**BUILDINGS 5 & 6
RENOVATIONS**

DSA BACK-CHECK

CAÑADA COLLEGE
4200 Farm Hill Boulevard
Redwood City, CA 94061

Date 12/31/08
Scale AS NOTED
Project Number 07013
Drawing Number S4.1

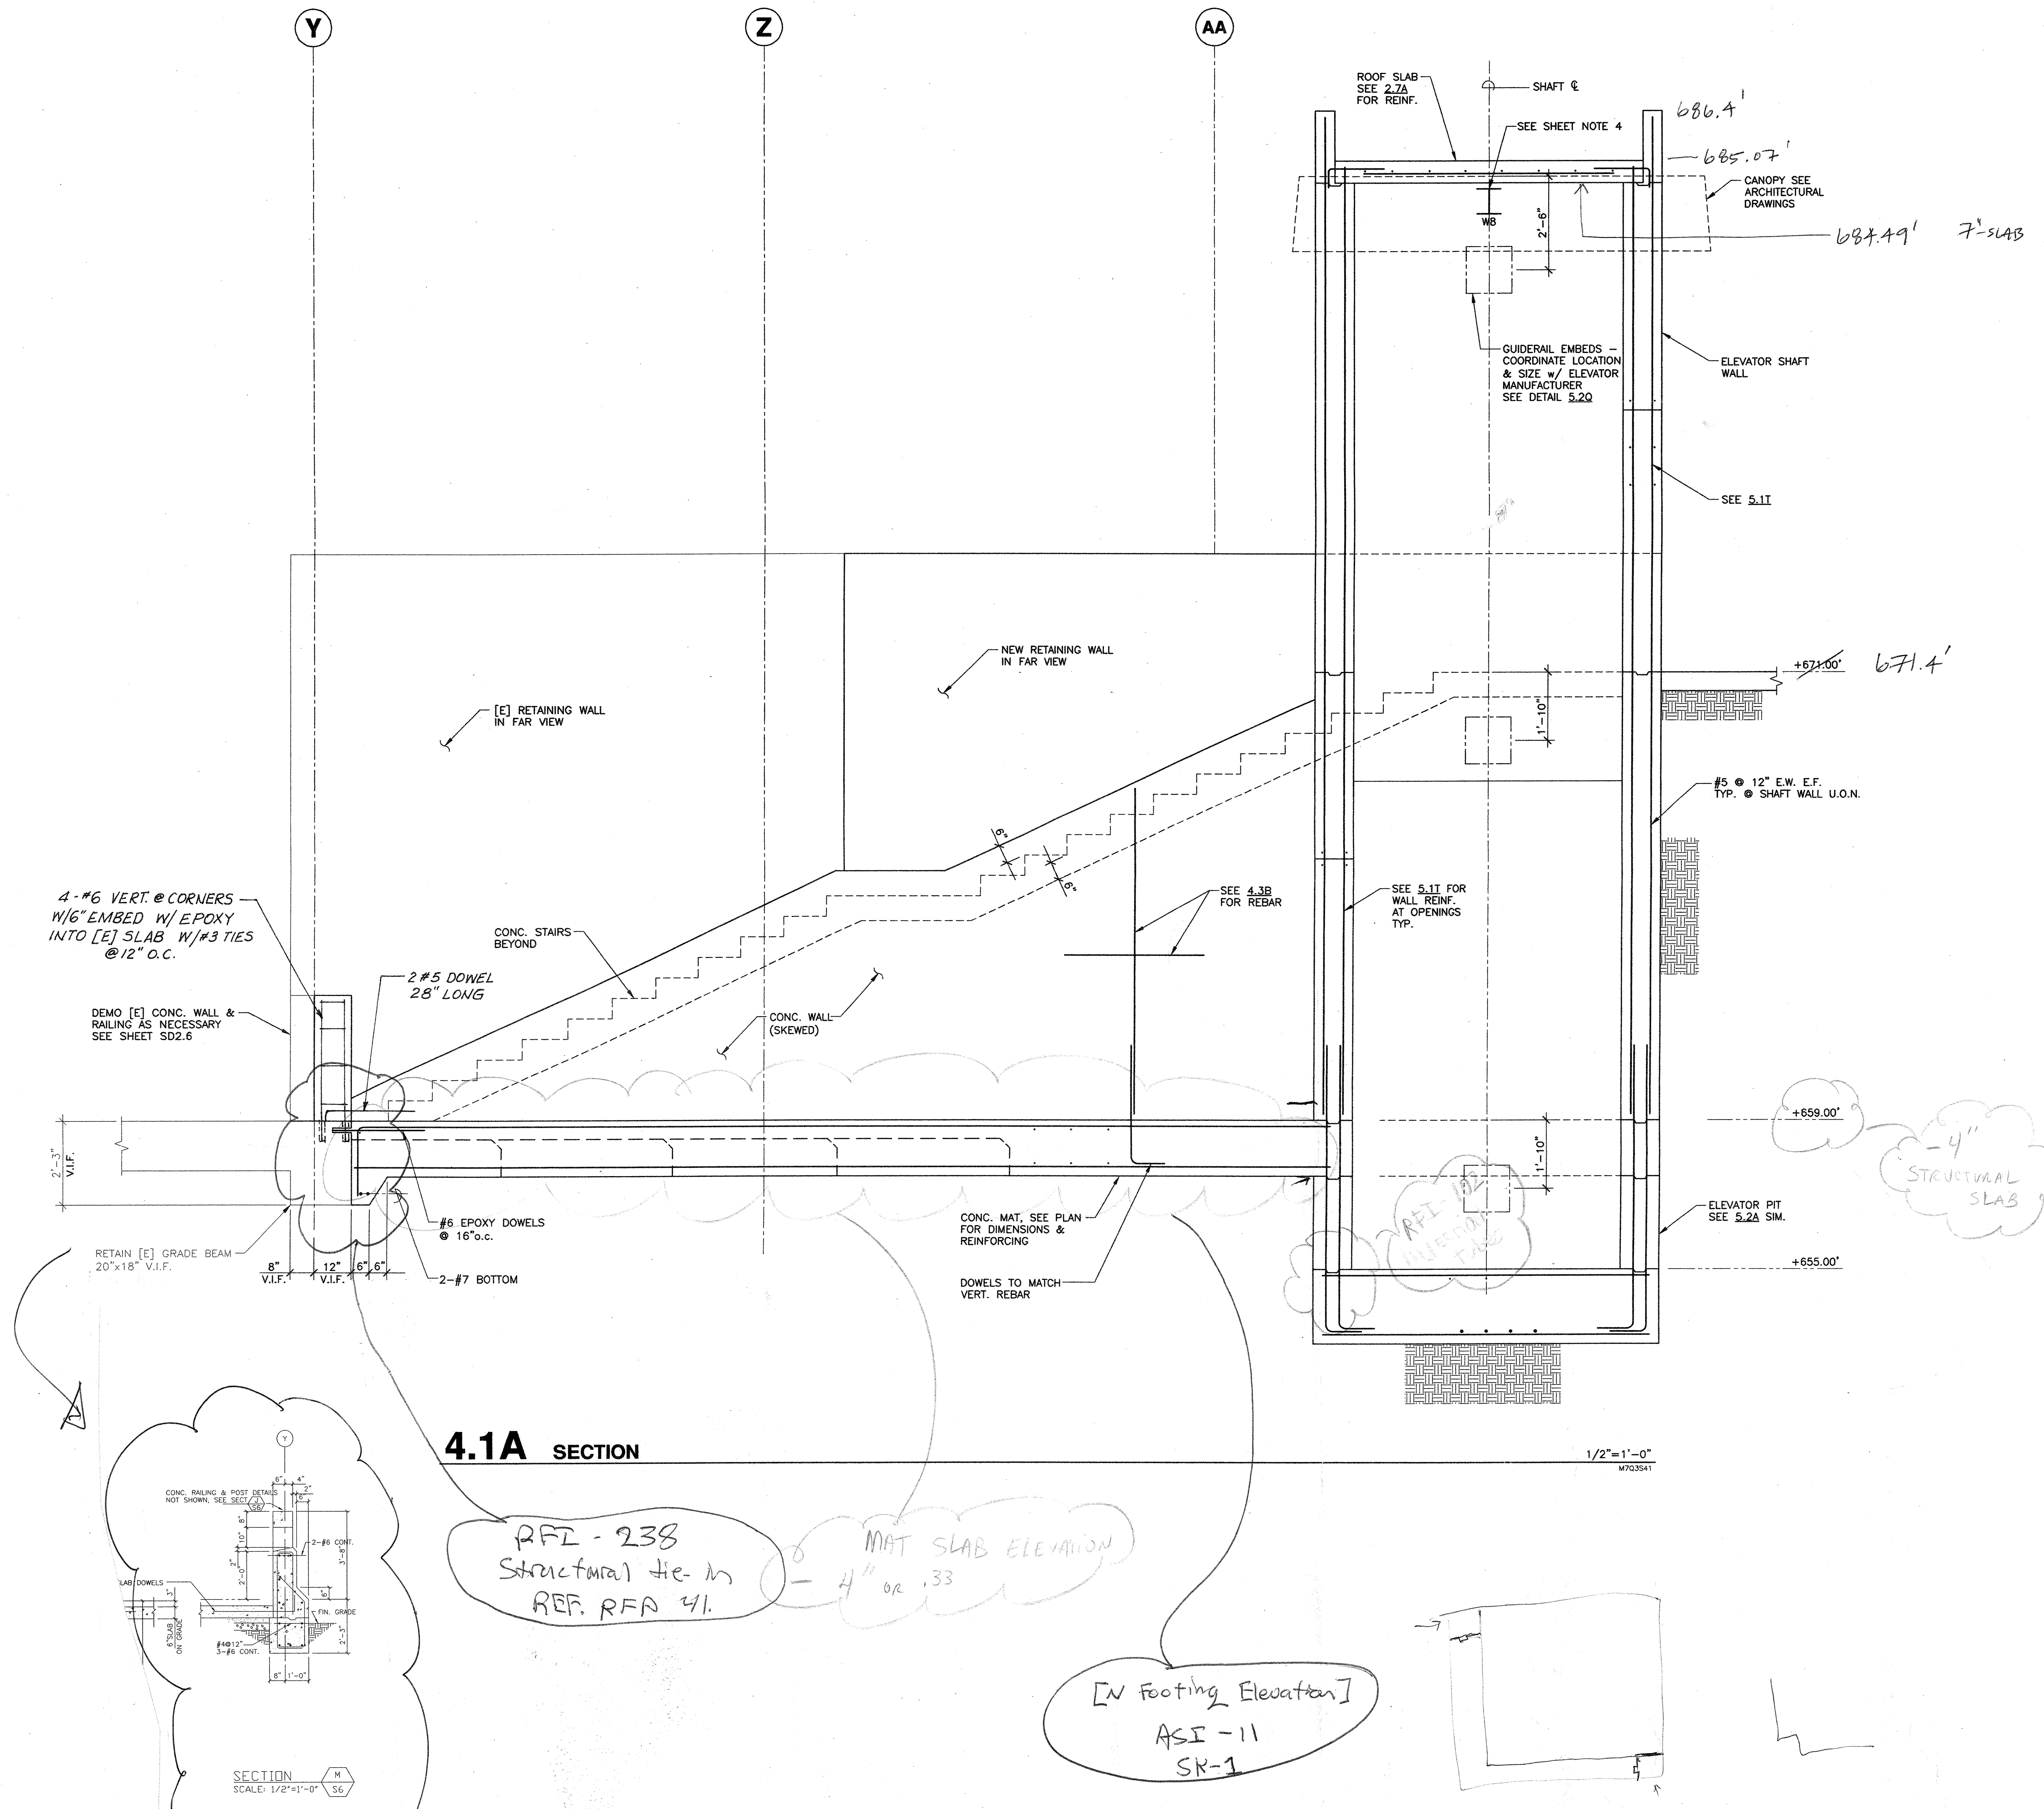
RFI - 238
Structural tie in
REF. RFD 41.

MAT SLAB ELEVATION
- 4" or .33

[N Footing Elevation]
ASI - 11
SR-1
